5509

**ACCESS AND FRONTAGE LANDSCAPING VARIANCES
TO ALLOW A 12' WIDE TWO-WAY DRIVEWAY AND
PROVIDE 802 SQUARE FEET OF FRONTAGE
LANDSCAPING (49.5% OF THE 12% TOTAL SITE
LANDSCAPING) IN AN R-B, RESIDENTIAL BUSINESS
DISTRICT; THE ORDINANCE REQUIRES A 24' WIDE
TWO-WAY DRIVEWAY AND 972 SQUARE FEET OF
FRONTAGE LANDSCAPING (60% OF THE 12% TOTAL
SITE LANDSCAPING) IN AN R-B, RESIDENTIAL
BUSINESS DISTRICT.**

260 NORTH JACKSON STREET

BOARD OF ZONING ADJUSTMENT

SITE PLAN

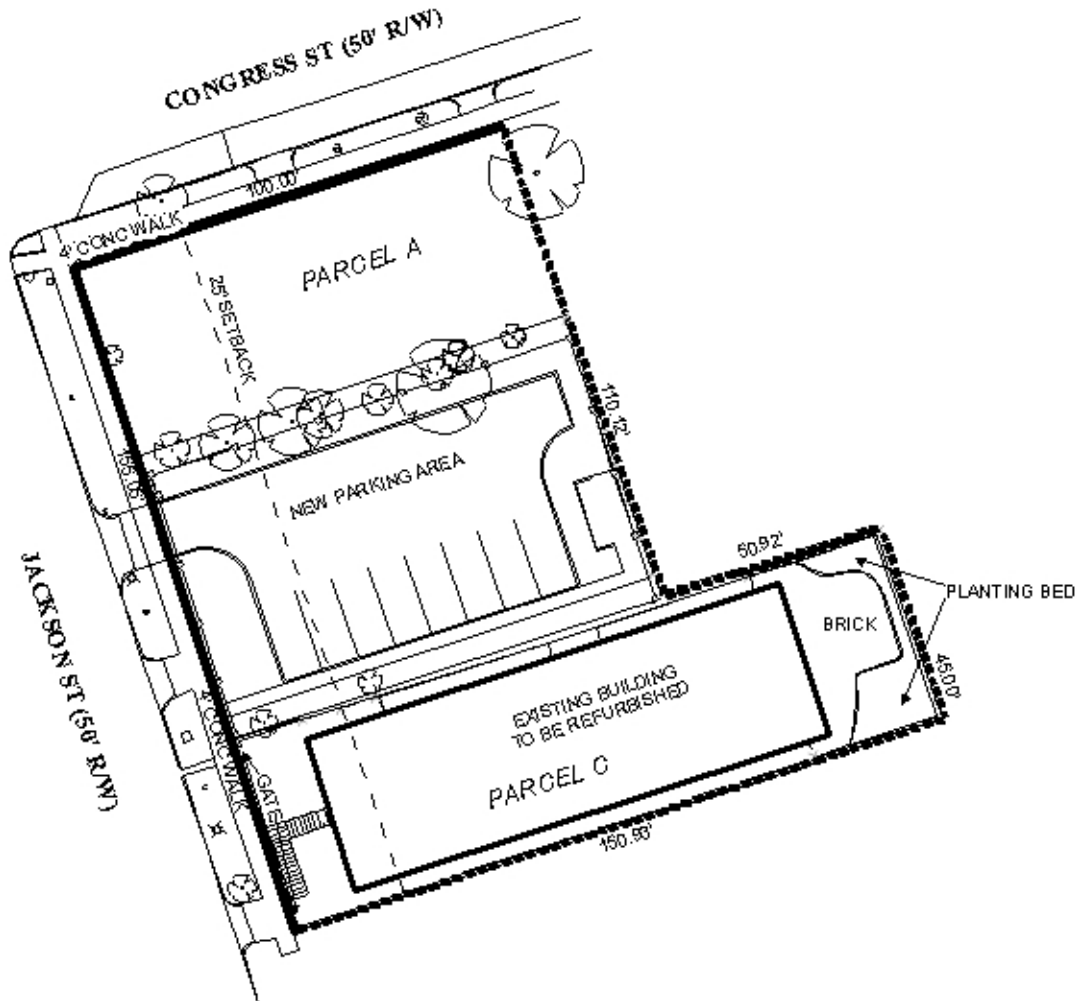
According to the applicant, the plan is to renovate an existing two-story building into four residential dwelling units. Eight paved parking spaces will be provided (two per dwelling unit), which will be enclosed within a 6' high wall for privacy and security purposes. However, the applicant does not wish to provide the required 24' entrance into the site because it will present too much of a commercial "feel" to the development and diminish the intimate residential appearance that the developer wishes to create; also noted are similar approvals for other residential developments in the area. The applicant further states that the presence of brick pavers on the property is preventing compliance with the frontage landscaping requirement.

After reviewing Mobile City aerial photographs, it appears that the 12' drive would keep in line with the residential appearance of this area of North Jackson Street however; there appears to be at least 3 commercial sites within 500' of the property that have a 24' entrance. In addition, after research, no approved access variance cases were found in the immediate vicinity that allowed for a 12' two-way driveway. It should be noted that if approved, addition of a gate to the entrance would cause an impact on the traffic flow therefore a note should be placed on the site plan stating that there will be no gated entry to the property.

According to the landscape requirements, 12% of the total building site shall be landscaped and 60% of that total shall be located between the street line and the front of the building. According to the applicant, they are required 1620 square feet of landscaping with 972 square feet located in the front. They have proposed 3195 square feet of landscaping but are only able to locate 802 square feet in the front due to existing brick pavers that cover the area between the existing building and the street line and an existing brick wall. According to the site plan submitted, there appears to be two curb cuts that will not be in use by the property owner. If approved, these curb cuts should be taken out and replaced with landscaping to aid the owner in his fulfilling his landscaping requirements.

- 1) placement of a note on the site plan stating there will be no gated entry to the property;
- 2) obtainment of approval from the City of Mobile Architectural Review Board prior to the issuance of any permits;
- 3) removal of the two existing curb cuts not in use by the proposed development; and
- 4) completion of the subdivision process prior to the issuance of any permits.
